ADDENDUM NUMBER 1

Title: Katy Depot – Liberty Park Connect Sedalia Project
Owner: City of Sedalia, Missouri
Engineer: Wilson & Company, Inc., Engineers & Architects

ISSUE DATE: **September 16, 2025.**

SHEET NO:
14 OF 80

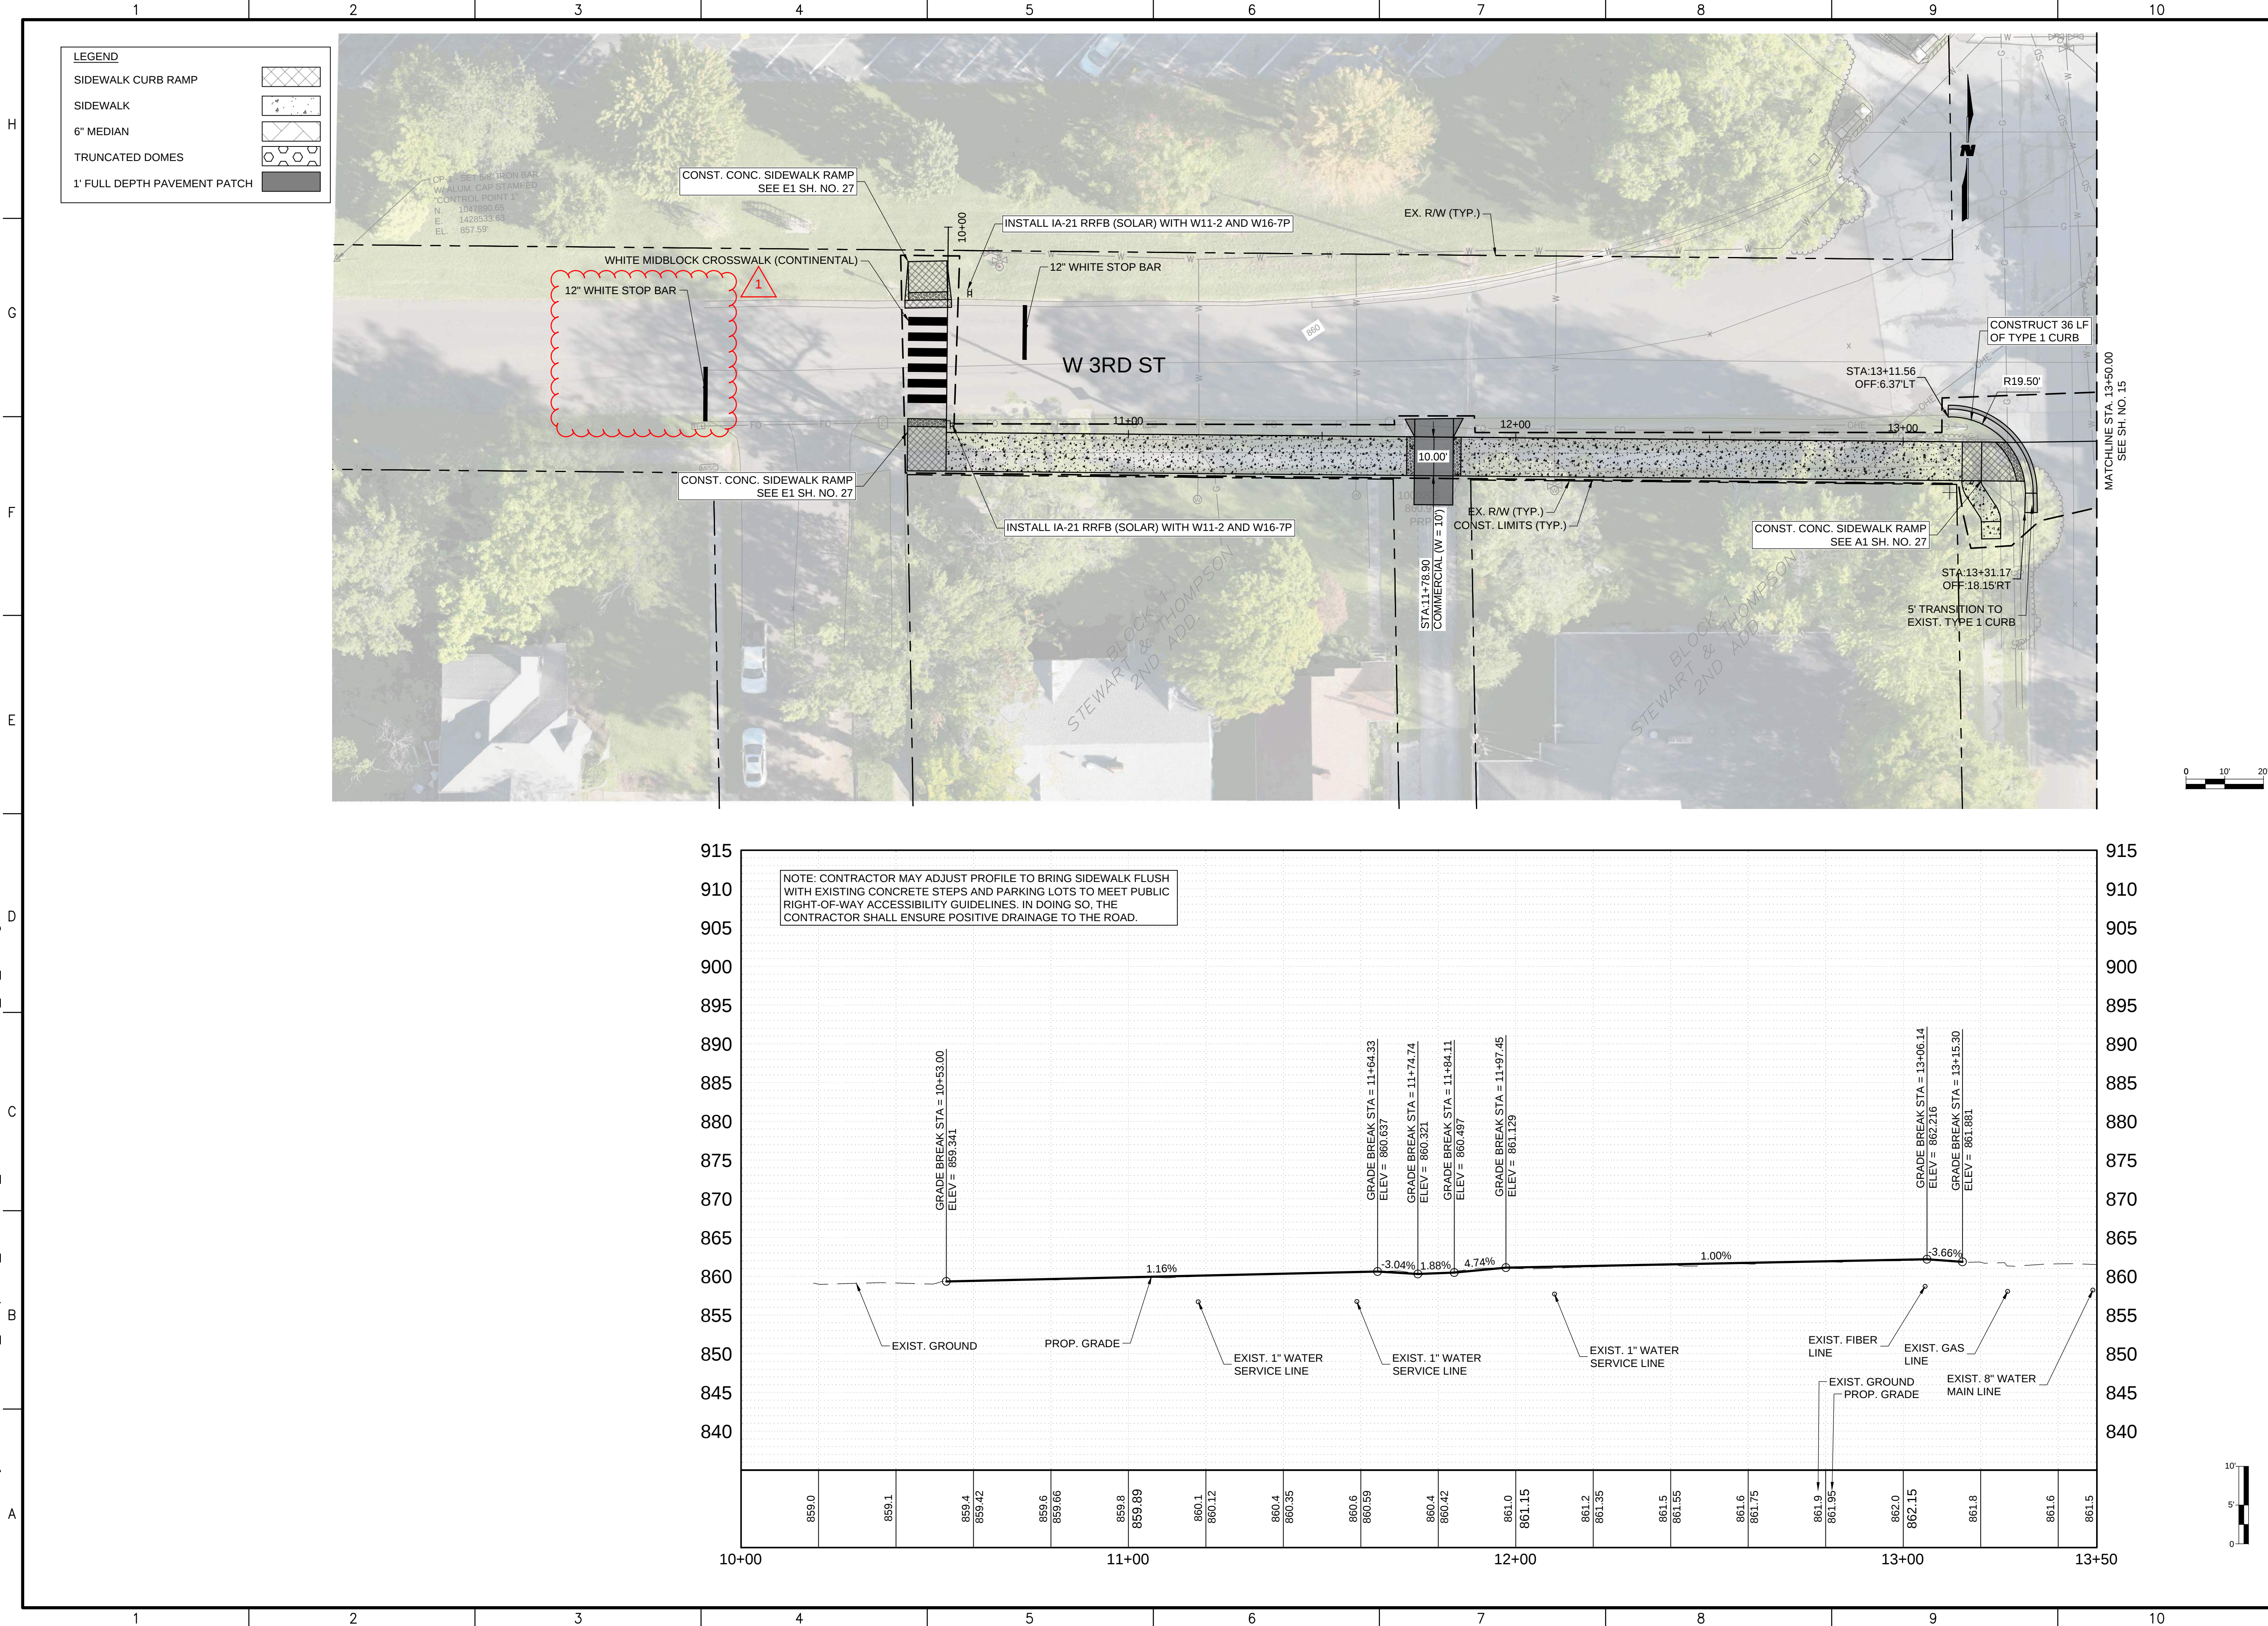
1. Plan Sheet #2; general note number 21 revised "sod" to "seeded" and bid item #25 quantity Remove and Reset Sign from 7 to 22.
2. Plan Sheet #14; Revised Location of Stop Bar going East on 3rd Street.
3. Plan Sheet #18; Added notes for removal and reset of an existing sign.
4. Plan Sheet #19; Added notes for removal and reset of an existing sign.
5. Plan Sheet #20; Added notes for removal and reset of an existing sign.
6. Plant Sheet #21; Added notes for removal and reset of an existing sign and removal of existing storm structure on southeast corner of 3rd Street and Osage Avenue.
7. Plan Sheet #46; Added Trench Drain detail.

SHEET NO:
46 OF 80

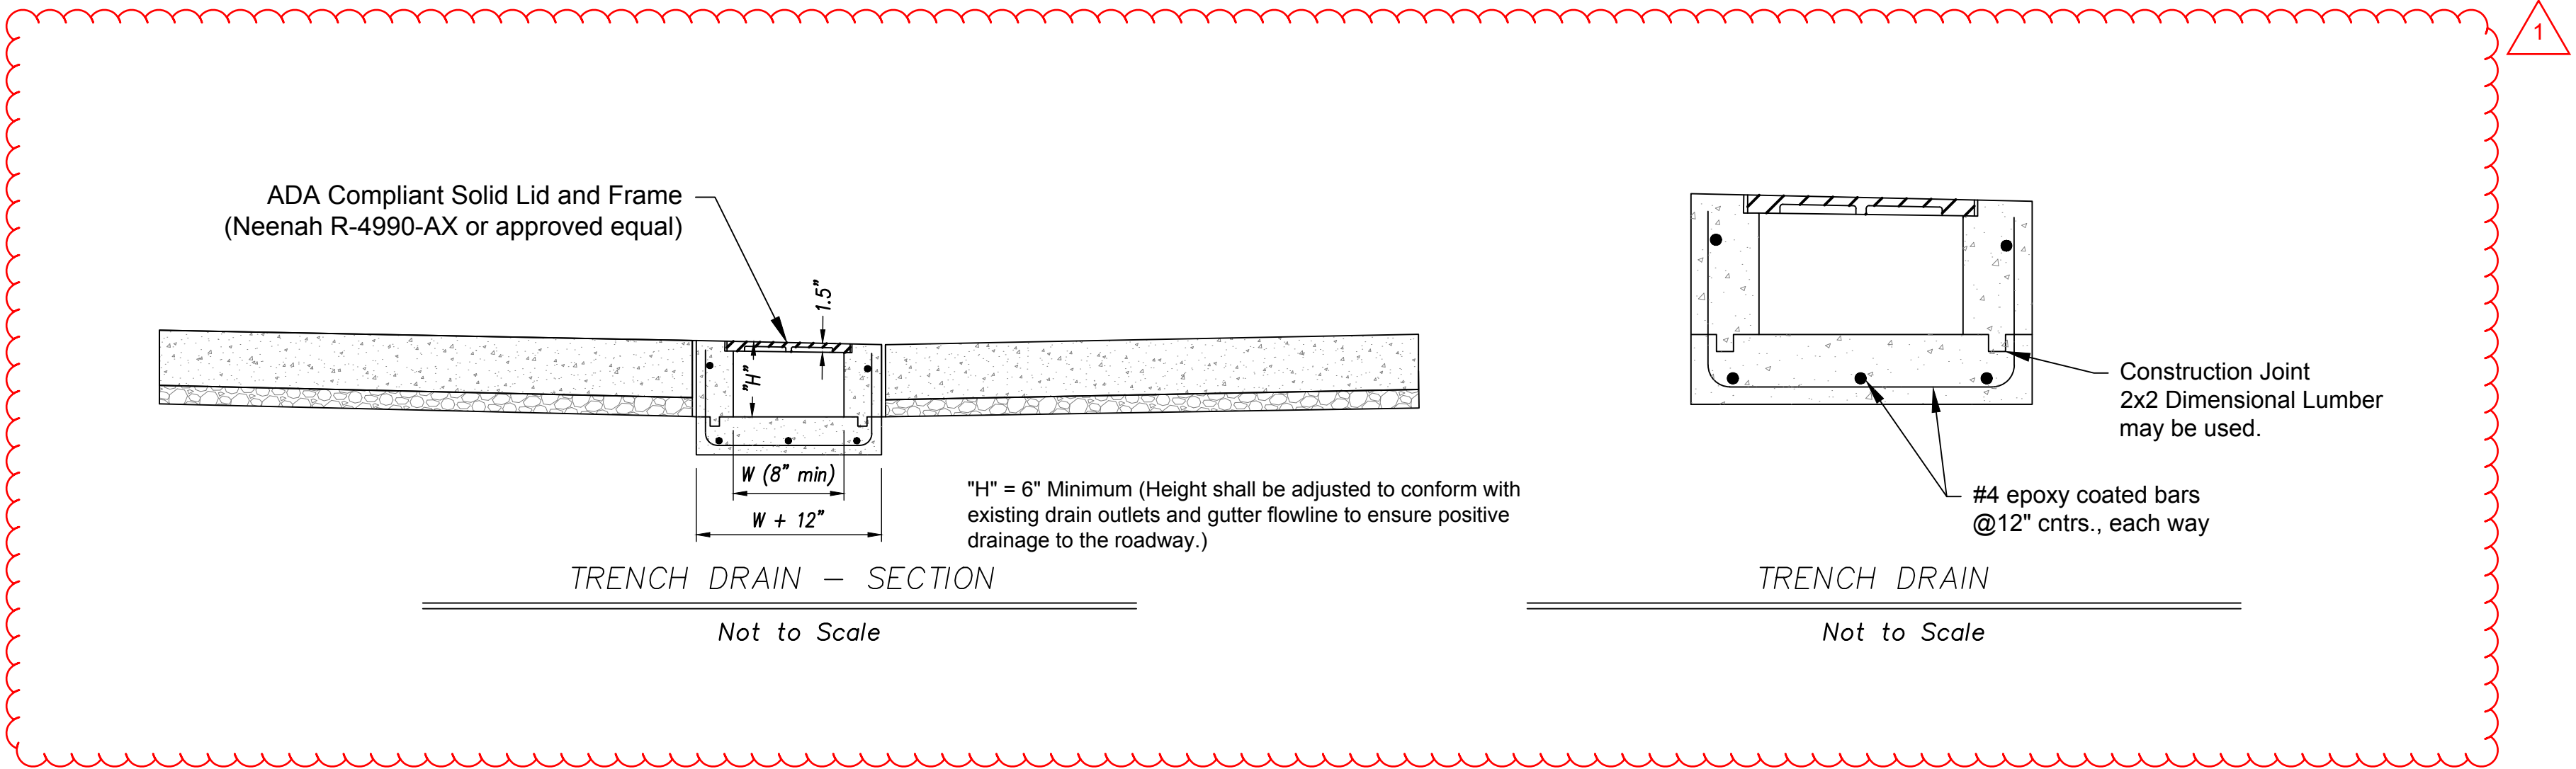
12. Gutter Drains – Is there a detail and could there be a pay item for gutter drains – I noticed at least 2 while onsite crossing the existing sidewalk.

Answer: A detail has been added to the miscellaneous detail sheet. This work shall be considered subsidiary to the sidewalk construction.
